Consultation Response from: KC Environmental Health (Pollution & Noise Control)
2025/92737 - rear of, 23 to 43, Moor Lane, Gomersal, Cleckheaton, BD19 4LF

Discharge of details reserved by conditions 10 (Phase II Intrusive Site Investigation Report), 11 (Remediation Strategy), 14(a) (coal mining activity), 16, 17, 18, 19, 20 (drainage), 21 (CEMP), 23 (estate roads), 24 (acoustic barrier) on previous permission 2023/92079 for outline application for erection of residential development of 10 dwellings, demolition of existing extension at 27 Moor Lane, widening of existing access and realignment of boundary walls.

Date Responded:
Wednesday, 27 May 2026
Responding Officer:
HK
Responding Ref:
WK/202533227

Access Road Eastern Elevation (towards 25 Moor Lane) as proposed 1: 100

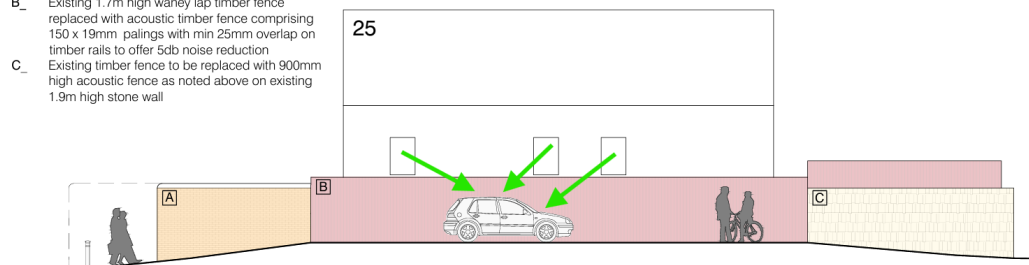
Condition 24: The submitted application form refers to: “*Condition 24: 21942-10 Access Road Elevations*” submitted for the discharge of condition 24. Environmental Health are not aware of the background / basis for condition 24, but it would appear that the purpose of an acoustic barrier in the location proposed would be to mitigate noise from road traffic accessing the site. Based on the information presented in the submitted drawing Ref: 21942-10 Access Road Elevations, dated July 2023, the proposed acoustic barrier could only achieve noise reductions at ground floor level. Noise from road traffic accessing the site will not be reduced by the installation of a noise barrier at first floor (bedroom window height). Noise reductions at first floor level could only be achieved by installing acoustic glazing – as can be seen in the drawing Ref: 21942-10 Access Road Elevations, dated July 2023:

A direct line of site  from first floor windows will not be mitigated by the acoustic barrier at the neighbouring dwellings. Furthermore, without a report prepared by a competent acoustic consultant, it cannot be confirmed that the proposed noise barrier will achieve the 5dB noise reductions.

Without further background, Environmental Health cannot comment further on condition 24.
